UNITED STATES PATENT AND TRADEMARK OFFICE

APPLICATION NO.	FILING DATE	FIRST NAMED INVENTOR	ATTORNEY DOCKET NO.	CONFIRMATION NO.
10/671,903	09/26/2003	Richard F. Gladney	SMCY-P01-104	8016

Office Action Summary

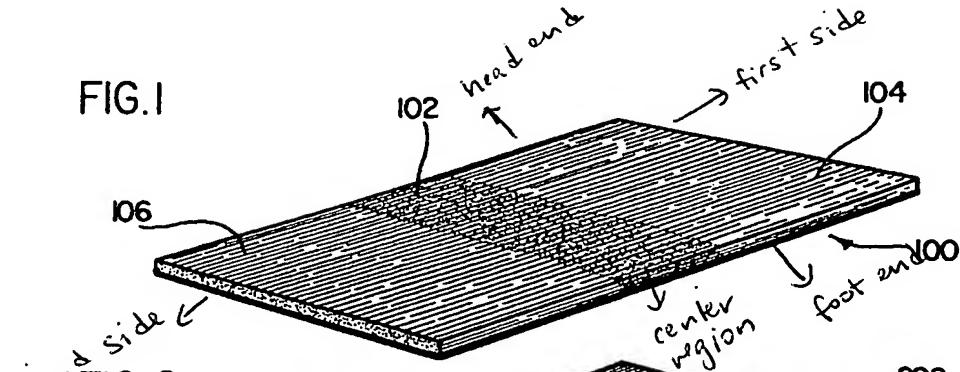
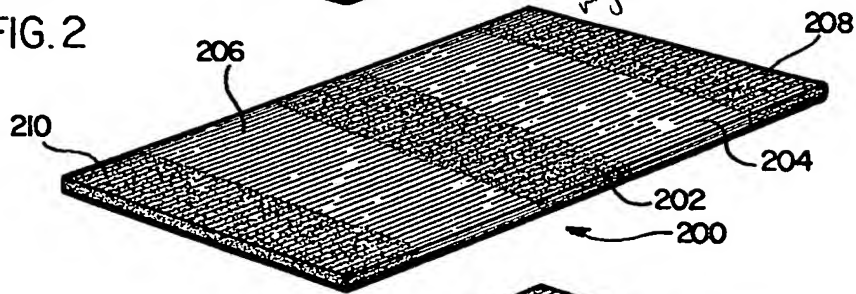
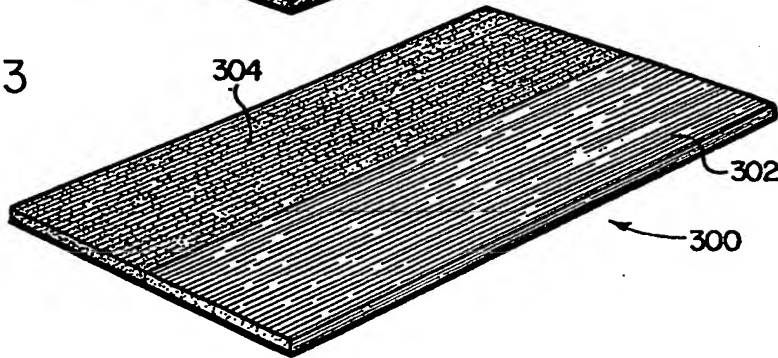
Selman et al. and Nunez et al. both disclose a mattress comprising a head end, a foot end, a first side and a second side (see attached marked up drawings) and a center region (102, 44) traversing the mattress from the head end to the foot end, the center region including one or more materials that mitigate the emergence of a center ridge over repeated uses of the mattress the center region. The center firmness is increased (see col. 3 lines 20-60, col. 4 lines 25-35 respectively). The center region is separated by an approximately equal distance from the first side and the second side.(see Figs. 1 and 2 respectively). (Re claims 7 and 8) the quilted material and upholstery is considered as the members shown in Figs. 1 and 2 respectively. Selman et al. and Nunez et al. both disclose the invention substantially as claimed. However, they are both silent about the center region having a width of between about two inches and about twelve inches. Farley '849 and Farley '179 both teach a center region (207, 26) having a width of between about two inches and about twelve inches (see col. 15, col. 5 respectively). It would have been considered obvious to one of ordinary skill in the art to modify either Selman et al. or Nunez et al. by making the width of the center region about 2-12 inches as taught by either Farley '849 or Farley '179 since such a modification would support the buttocks area adequately of an individual laying parallel to the longitudinal axis of the mattress.
